MWO 5-2350-262-35-1

## MODIFICATION WORK ORDER

### MODIFICATION OF ARMORED COMBAT EARTHMOVER (ACE), M9

### SYSTEM IMPROVEMENT PLAN (SIP) PHASE 4 BLOCK MODIFICATION

**Figure 2-1. Quick-Disconnect Reinstall at Air Compressor**

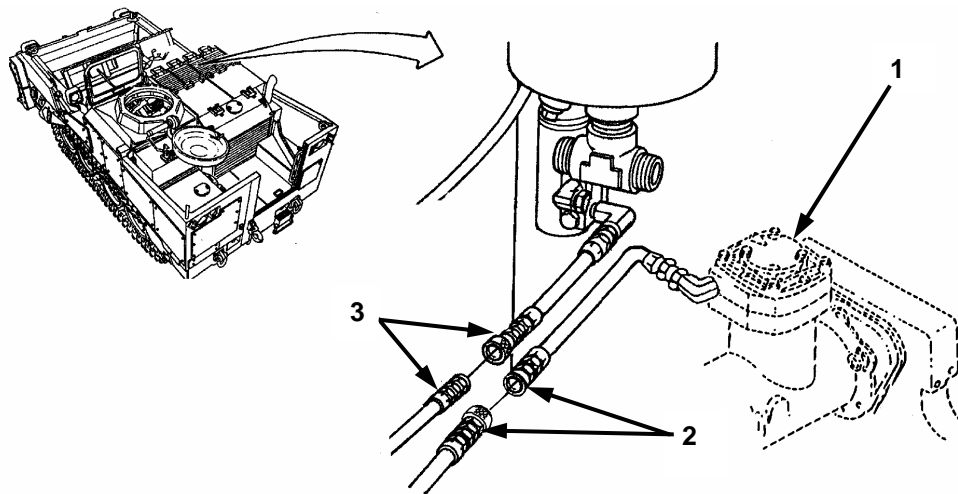
- b. Remove and reinstall quick-disconnect (2) on air compressor line with male coupling to air compressor (1). Verify quick-disconnect (3) on fuel return line has male coupling to fuel tank.

**Figure 2-2. Quick-Disconnects and Guide Pin at Lower Rear Engine Bulkhead**

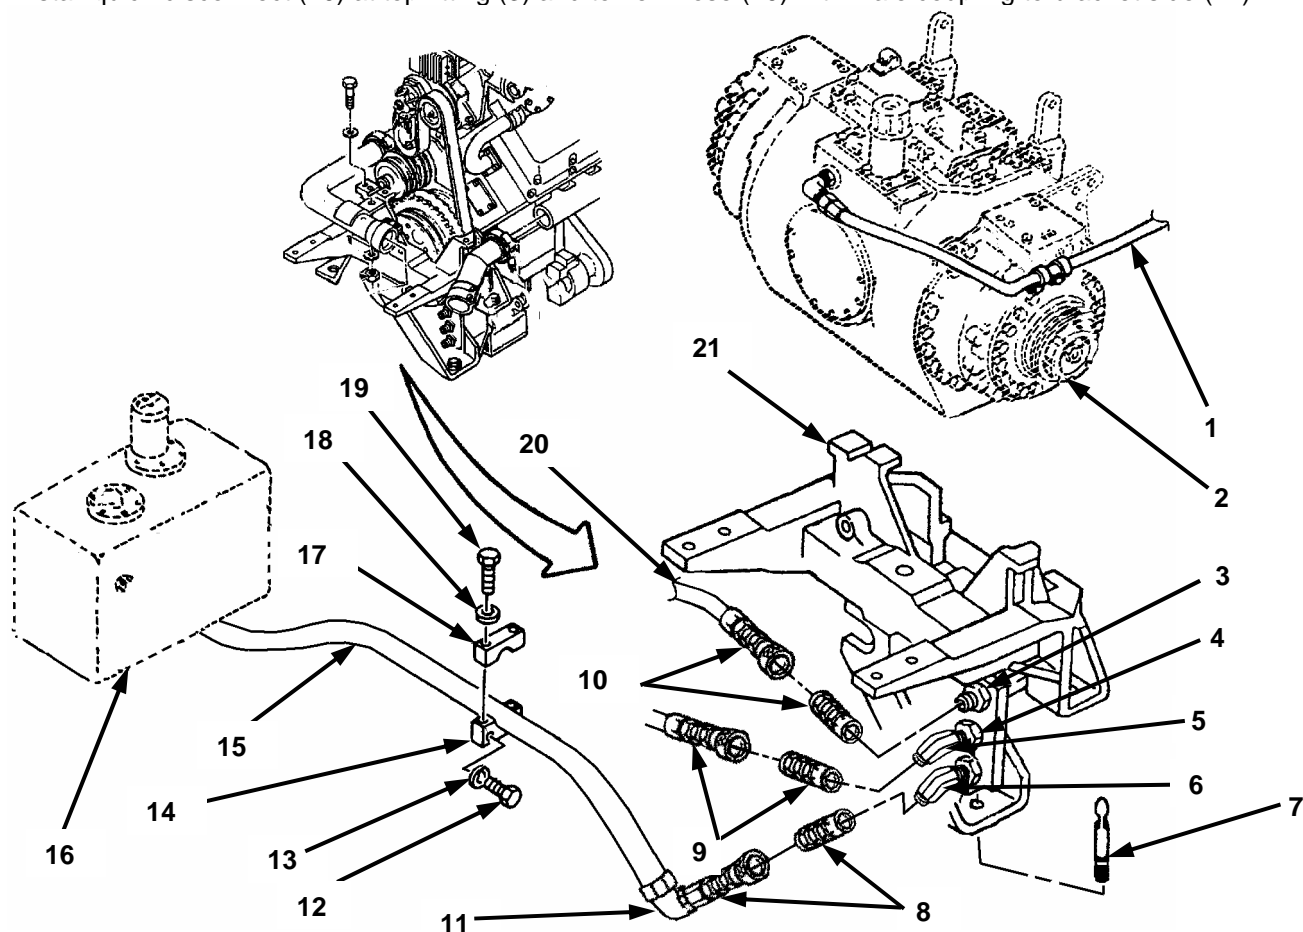
- d. On top fitting (3) of bracket (21), remove and discard hose (1) from rear of steer unit (2).
- e. Install quick-disconnect (10) at top fitting (3) and to new hose (20) with male coupling to bracket side (21).

- f. On middle fitting (4) of bracket (21), remove and discard 45° elbow MS51509A24 and install 35° elbow (5), facing down, on bracket.
- g. Install quick-disconnect (9) at middle fitting (4) on bracket (21) with male coupling to bracket side.
- h. Remove and discard two bolts (19), washers (18), and bracket (17) from bracket (14) on hull bottom plate.
- i. Remove and discard hose 13214E2551 and tube 12325766 from bottom fitting (6) of bracket (21) and hydraulic tank (16) bottom.
- j. Remove and discard bracket (14) from hull bottom plate, using method (1) or (2):
  - (1) Remove and discard two bolts (12), washers (13), and bracket (14) from hull bottom plate.

- (2) Using suitable aluminum cutting tool, cut and discard welded bracket (14) from hull.
  - (a) Grind raw area smooth on hull bottom plate using a suitable aluminum grinding tool.
  - (b) Clean, prime, and paint raw area using suitable CARC primer and finish paint per TB 43-0209.
- k. Install quick-disconnect (8) at bottom fitting (6) on bracket (21) with male coupling to bracket side.
- l. Install new 90° elbow (11) on one end of new hose (15).
- m. Install female quick-disconnect half (8) to 90° elbow (11).
- n. Route hose (15) on hull bottom in front of steer unit (2) and install hose end on bottom of hydraulic tank (16).
- o. Install guide pin (7) at lower rear engine mounting point.
- p. Install power package per TM 5-2350-262-34, Power Package Replacement–Installation, with following changes:

**Figure 2-3. Compensating Pump between Hose and Elbow**

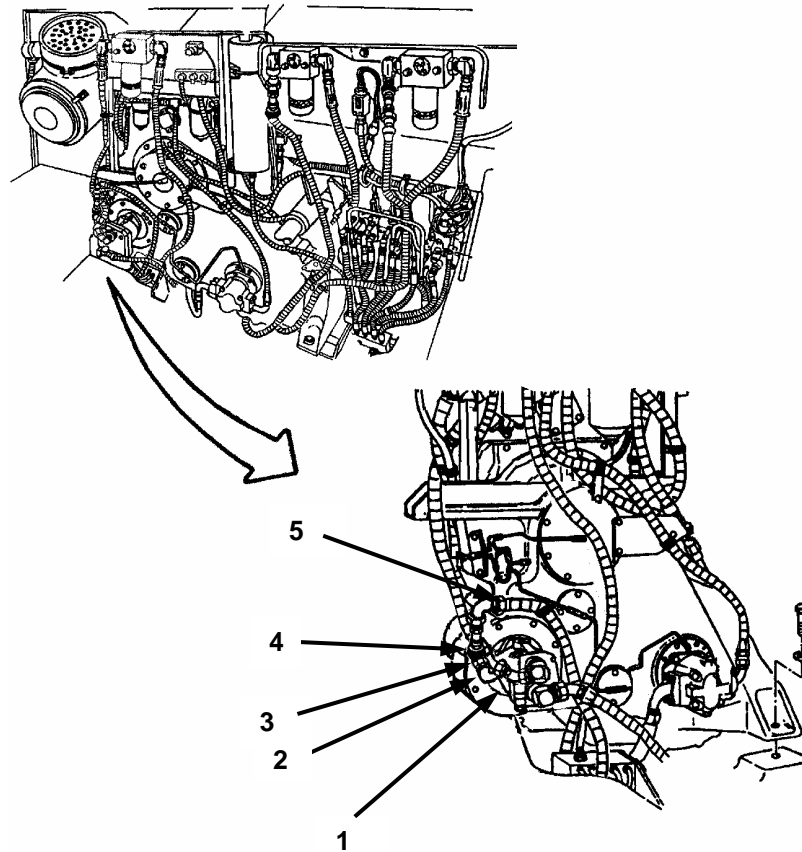
- (1) While performing TASK F per TM 5-2350-262-34, Power Package Replacement–Installation, adjust 90° elbow (2) on compensating pump to face up and angle towards transfer case.

- (2) Install quick-disconnect (3) on compensating pump at elbow (2) with male coupling to compensating pump.
- (3) Install new 90° elbow (4) to female half quick-disconnect coupling (3).
- (4) Reroute hose (5) up through front tubes on manifold, next to compensating pump, and above compensating pump to 90° elbow (4).

Figure 2-4. Hull Bottom Plate

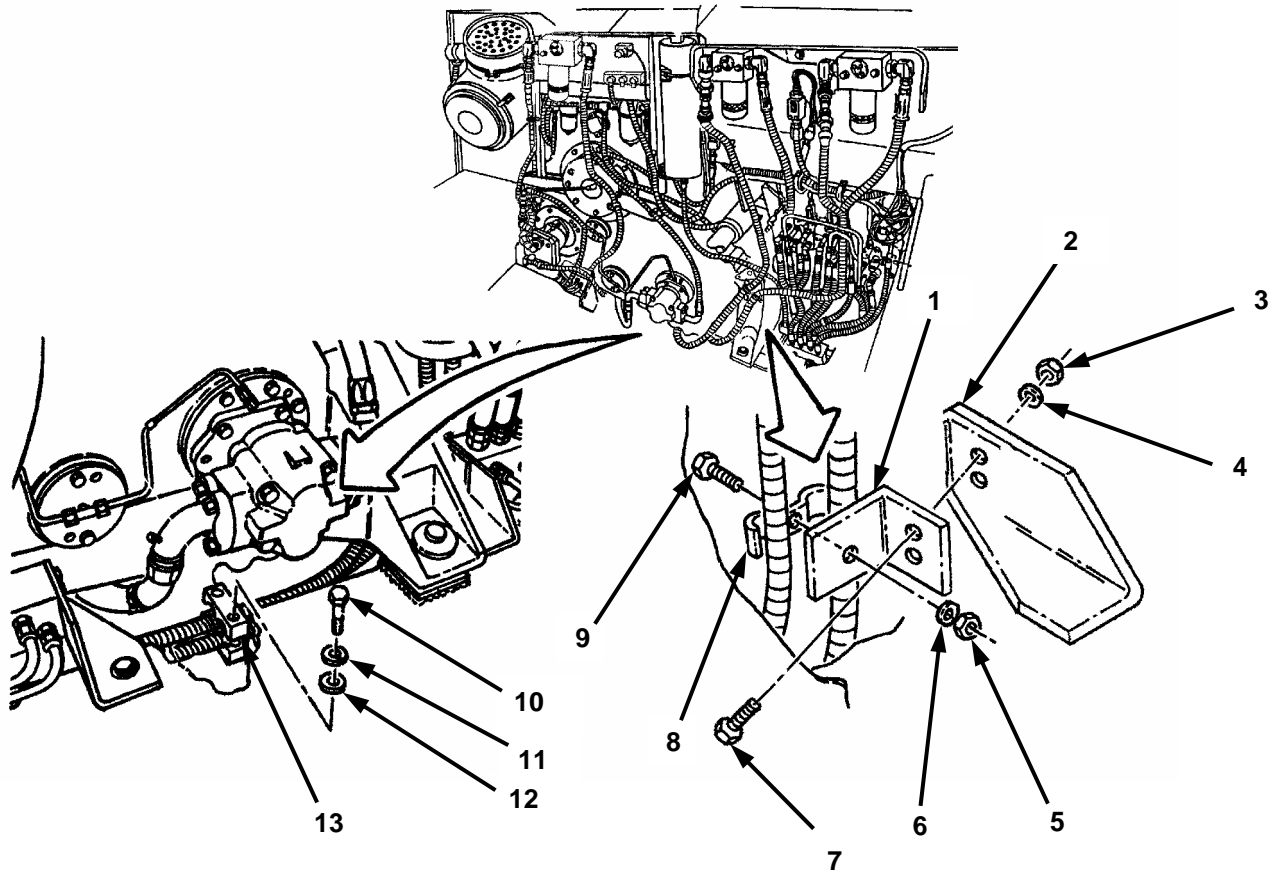
- (5) While performing TASK J and K per TM 5-2350-262-34, Power Package Replacement–Installation, perform the following steps:
- (a) Remove and discard cap screw (9), retaining strap (8), flat washer (6), and nut (5) from bracket (1).
- (b) Remove and discard two cap screws (7), flat washers (4), nuts (3), and bracket (1) from plate (2).
- (c) Remove and discard two machine bolts (10), retaining strap (13), flat washers (11), and nuts (12) from hull bottom plate.

**Figure 2-5. High Pressure Filters**

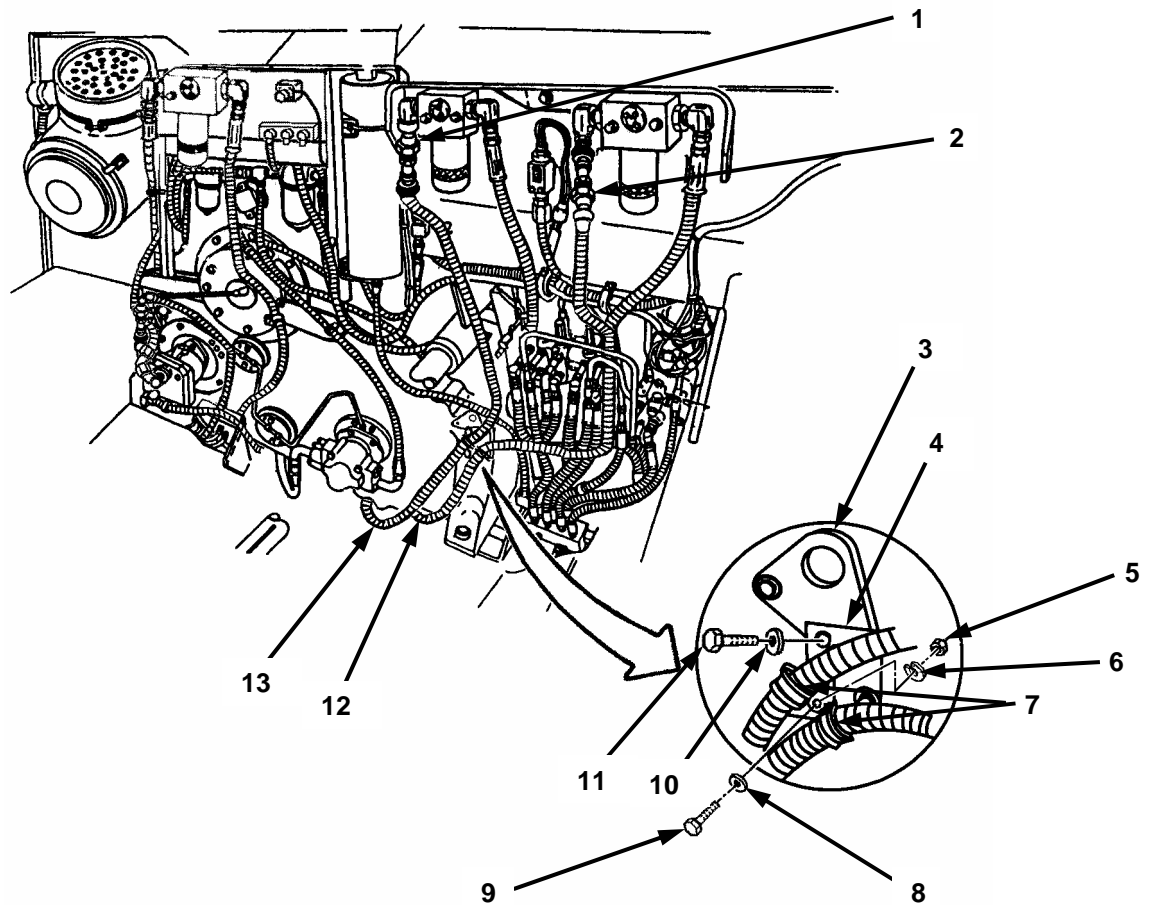
- (6) Reroute hoses (12 and 13) in front of engine transfer case, between scavenger pump and transfer case motor mount.

- (7) Install new bracket (4) to lifting eye (3) at bottom two bolt locations with existing two bolts (11) and washers (10).
- (8) Secure hoses (12 and 13) with clamps (7) to front of bracket (4) with screw (9), flat washer (8), lock washer (6), and nut (5).
- (9) Install quick-disconnect (1) at power package side high pressure filter with male coupling to high pressure filter.
- (10) Install quick-disconnect (2) at driver's compartment side high pressure filter with female coupling to high pressure filter.

**Figure 2-6. Main Hydraulic Accumulator**

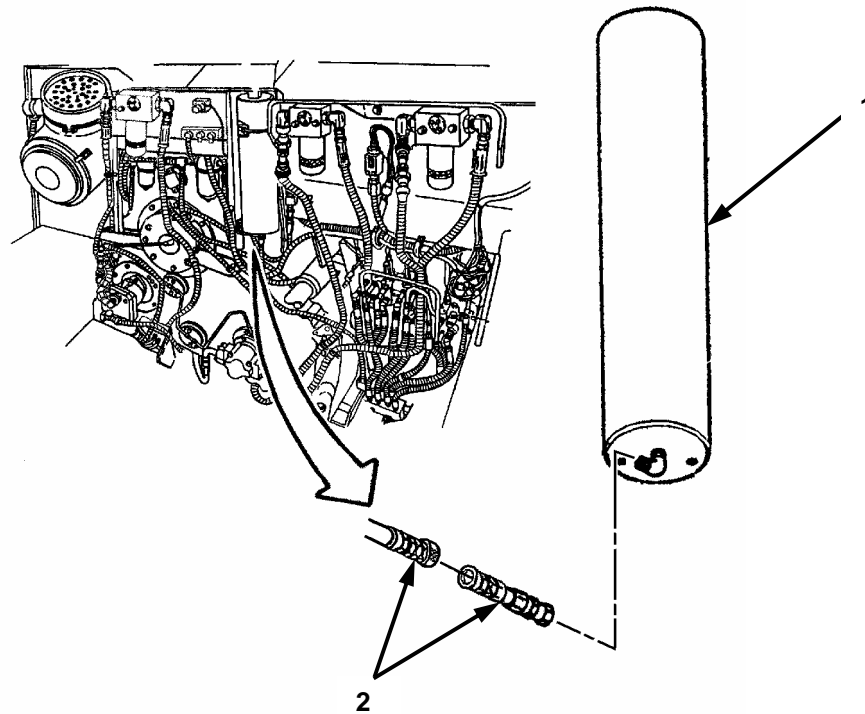
- (11) While performing FOLLOW-ON TASKS per TM 5-2350-262-34, Power Package Replacement–Installation, install quick-disconnect (2) at bottom of main hydraulic accumulator (1) with male coupling to main hydraulic accumulator.

**Figure 2-7. Ejector Cylinder**

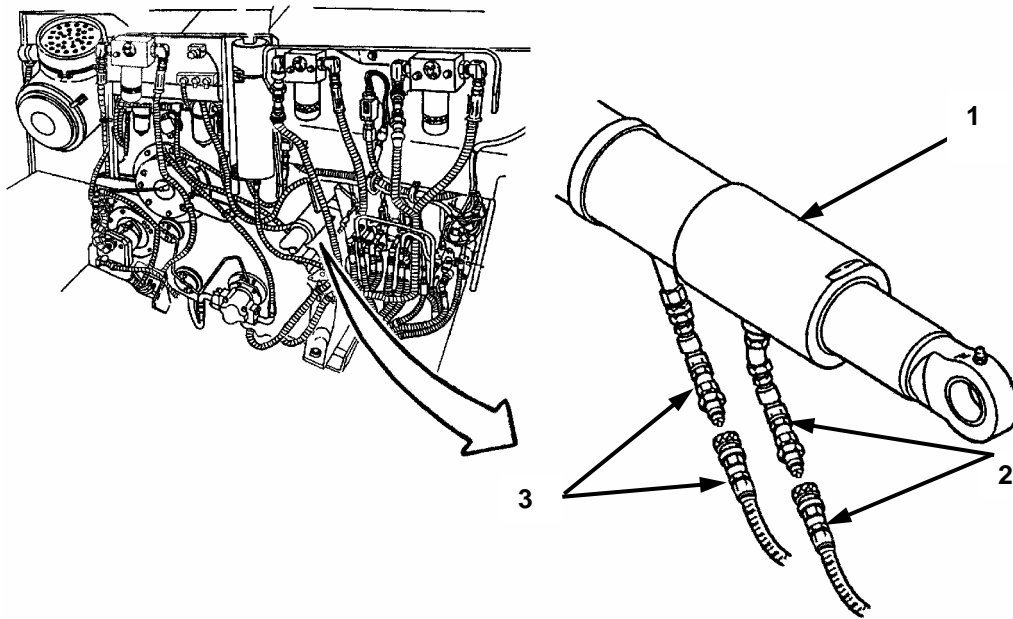
- (12) While performing FOLLOW-ON TASKS per TM 5-2350-262-34, Power Package Replacement–Installation, install two quick-disconnects (2 and 3) at ejector cylinder (1) with male couplings to ejector cylinder.

Figure 3-1. Fire Extinguisher Bottle Holder Shield

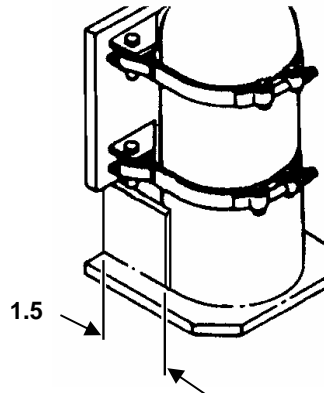
- d. Using suitable aluminum cutting tool, cut right side fire extinguisher bottle holder shield from holder, leaving 1.5 inches on each side (Figure 3-1).
- e. Using suitable aluminum grinder, smooth new edges and surfaces.

- f. Clean, prime, and paint raw area with suitable CARC prime and finish paint per TB 43-0209.

**Figure 3-2. Left Side Nozzle Bracket Installation**

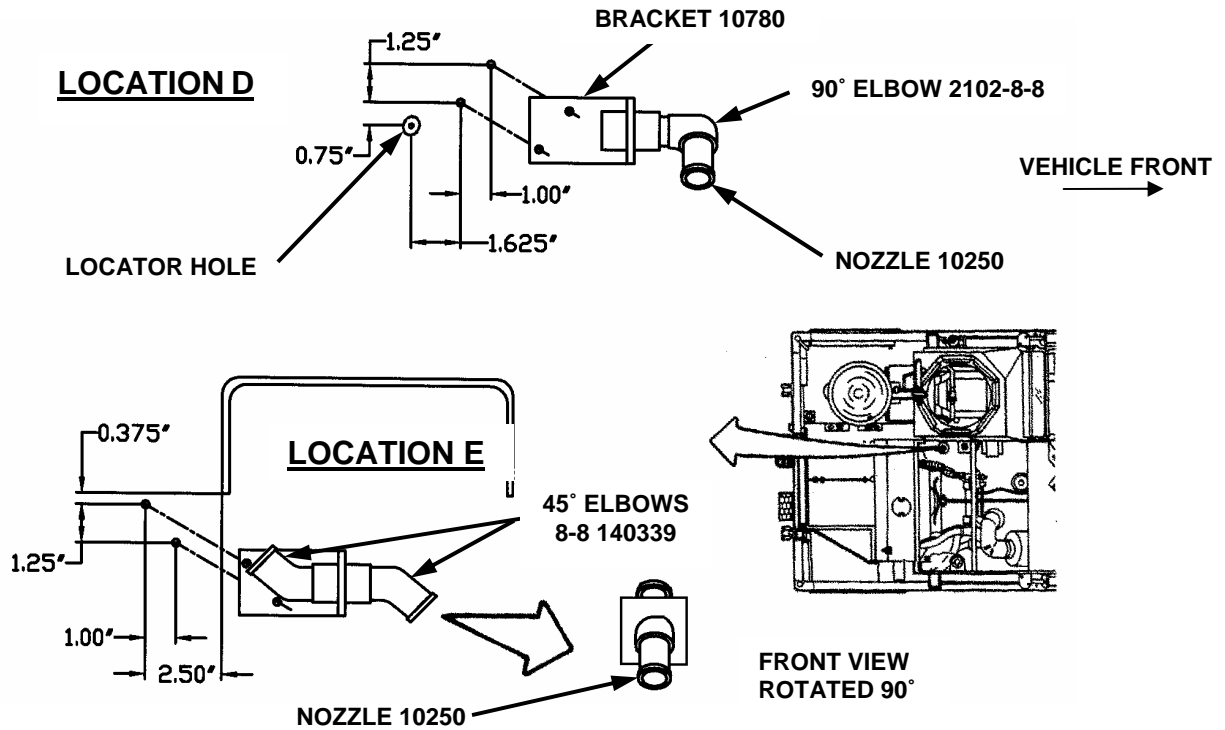
- a. Using suitable machinist's ruler, measure, mark, and center punch, for drilling and tapping four holes for two brackets (10780) on left side (Figure 3-2).
- b. Drill 4 x .25 x 20-UNC-2B holes .375 inch deep only and bottom end tap holes, ensuring maximum thread depth of .375 inch.
- c. Install two brackets (Figure 3-2) with four washers (MS27183-49) and screws (B1821BH025C050N).
- d. Install one 90° elbow (2102-8-8) and nozzle (10250) at LOCATION D (Figure 3-2). Using suitable machinist's protractor and straight edge, direct 90° elbow towards engine with 25° angle down from horizontal.

- e. Install two 45° elbows (8-8 140339) and one nozzle (10250) at LOCATION E (Figure 3-2).
- f. Direct forward 45° elbow at LOCATION E (Figure 3-2) towards vehicle front with 45° angle down. Direct rear 45° elbow at Location E (Figure 3-2) towards vehicle rear with 45° angle up.

Locator hole for Location D (Figure 3-2 above) is hole for fire extinguisher system cable into driver's compartment.

Figure 3-3. Left Side Installation

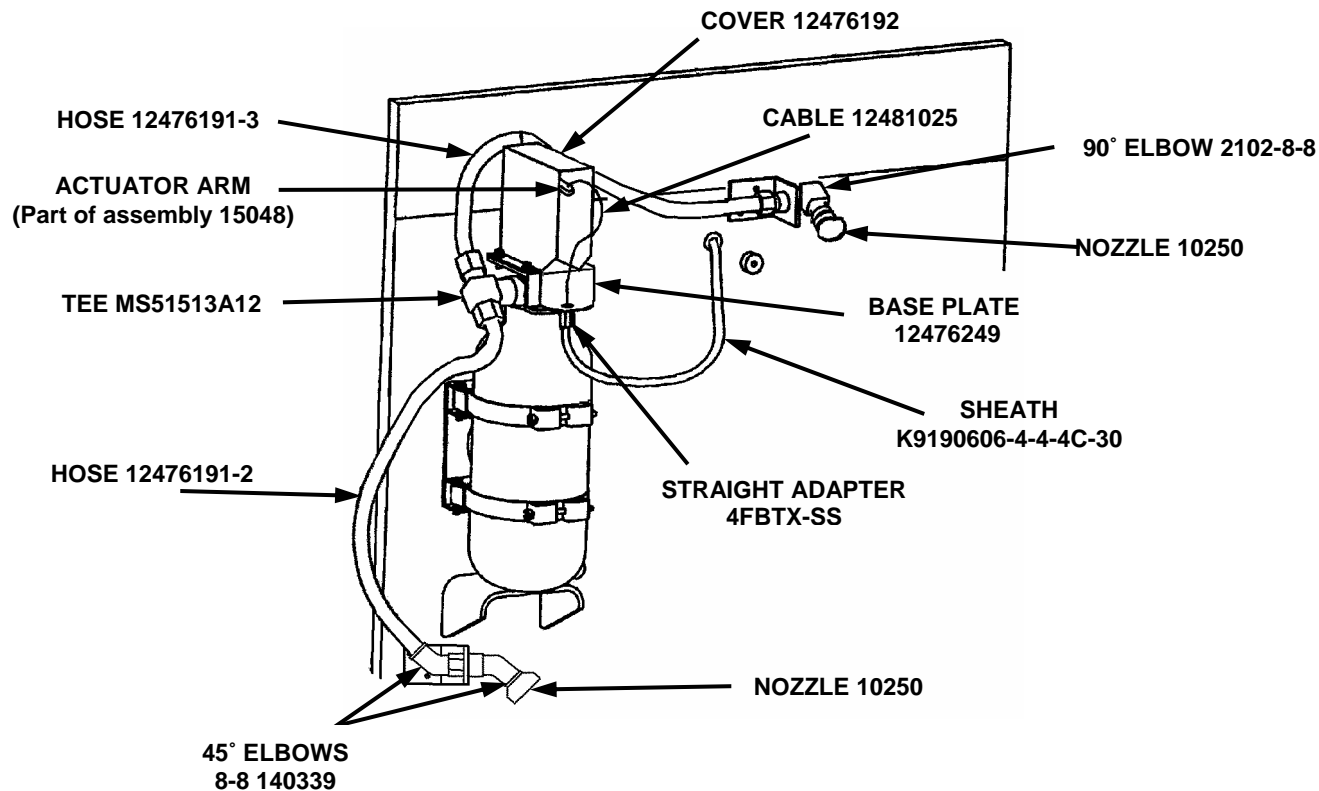
- g. Inside operator compartment, wire rope free play measurement should not exceed two inches (changed from four inches to two inches).
- h. Refer to Figure 3-3 below to verify placement of hoses and elbows.

Figure 3-4. Right Side Nozzle Bracket Installation

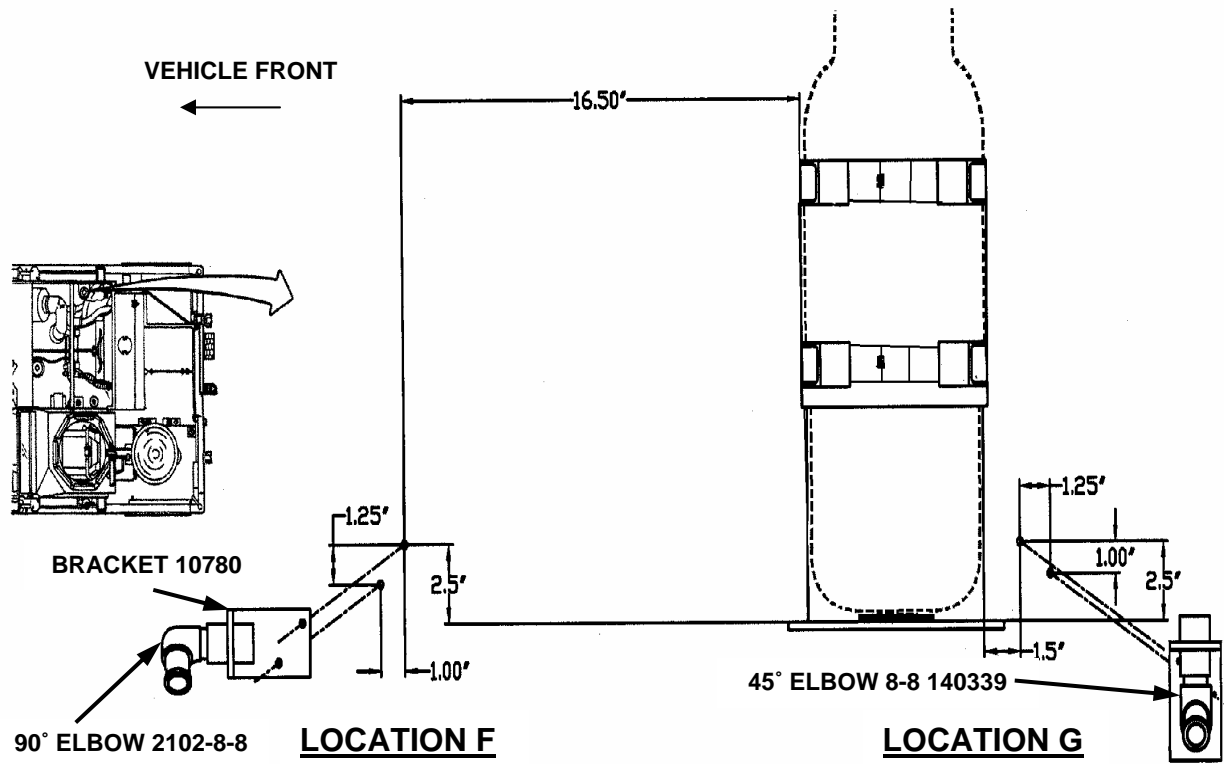
- a. Using suitable machinist's ruler, measure, mark, and center punch, for drilling and tapping four holes for two brackets (10780) on right side (Figure 3-4).
- b. Drill 4 x .25 x 20-UNC-2B holes .375 inch deep only and bottom end tap holes, ensuring maximum thread depth of .375 inch.
- c. Install two brackets (Figure 3-4) with four washers (MS27183-49) and screws (B1821BH025C050N).
- d. Install 90° elbow (2102-8-8) and nozzle (10250) at LOCATION F (Figure 3-4). Using suitable machinist's protractor and straight edge, direct 90° elbow towards engine at 10° down from horizontal.
- e. Install 45° elbow (8-8 140339) and nozzle at (10250) LOCATION G (Figure 3-4). Direct 45° elbow directly towards left side of vehicle.

Figure 3-5. Right Side Installation

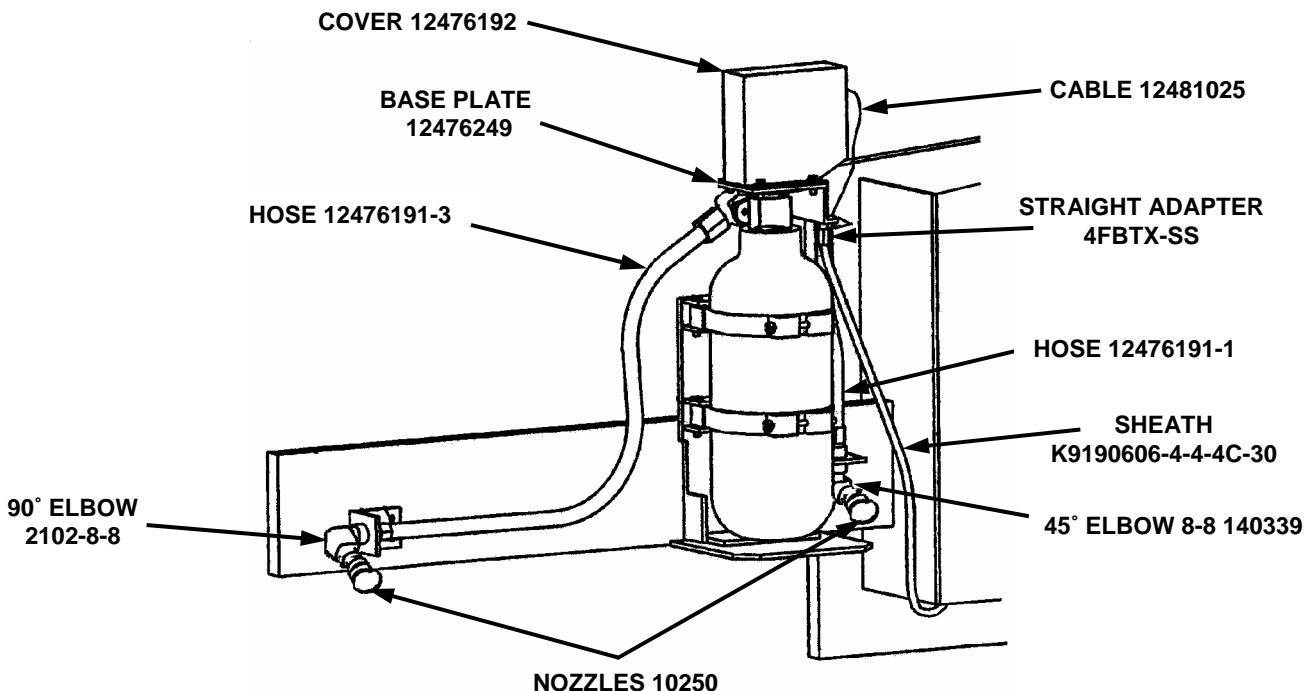
- f. Outside on right side of vehicle, wire rope free play measurement should not exceed two inches (changed from four inches to two inches).
- g. Refer to Figure 3-5 below to verify placement of hoses and elbows.
